INITIAL FIRE SAFETY INSPECTION REPORT

South East Textiles (Pvt.) Ltd. (Extension 2)

RSC ID: 26548

Date: 17-February-2026

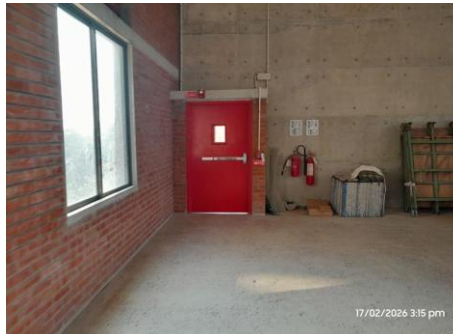
Sl No.	Category	Findings	Required Action	Remediation Time Frame
F-32	Means of Egress	Aisles were found missing in several locations throughout the building. Location(s): All floors (Generator Building).	Provide minimum aisle widths of 36-in. Aisles mark shall be clearly visible.	Within 1 Month

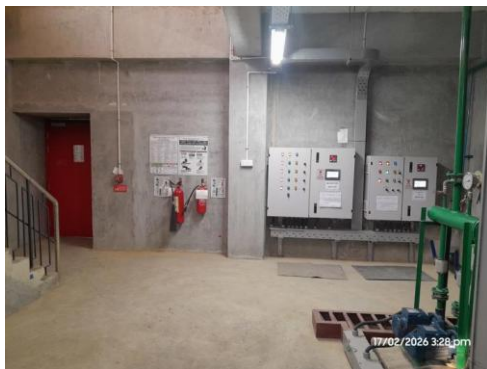
F-34	Means of Egress	Based on the number and location of emergency lights observed, adequate illumination levels are not anticipated along egress routes. Location(s): All floors (Generator Building).	Test the emergency lighting system on each floor and provide additional emergency fixtures to provide adequate illumination along the means of egress. Provide a minimum illumination of 10 lux at the floor level within exit stairs and exit discharge paths, and minimum 2.5 lux along exit access aisles. Illumination on means of egress shall meet in accordance with RSC Technical Guidelines (Standard)¹ V1.0 Section 10.12.2.	Within 3 Months
